Design Change of Transceivers for Wireless Positioning Units "EPC-200-CC"

[Information About Changes]

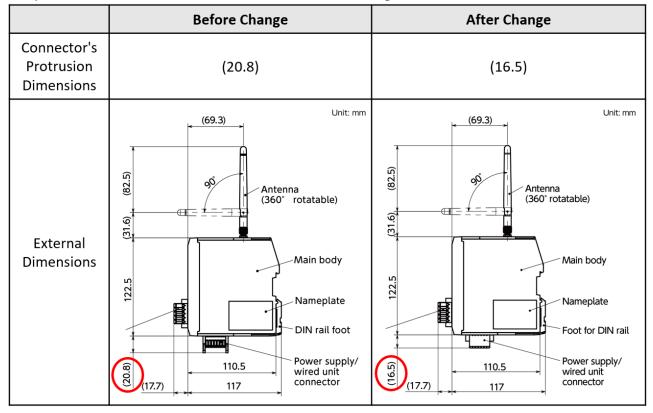
• Power supply/wired unit connector It will be change to 2-connection per pole.

Before Change	After Change
Manufacturer	PHOENIX CONTACT	PHOENIX CONTACT
Part Number	FK-MCP 1,5/ 7-ST-3,5-LR	TFMC 1,5/7-STF-3,5
Power supply/ wired unit connector	CB CS 24 0 0 SL	CA C

The protrusion dimensions will be smaller due to the change in the connector.
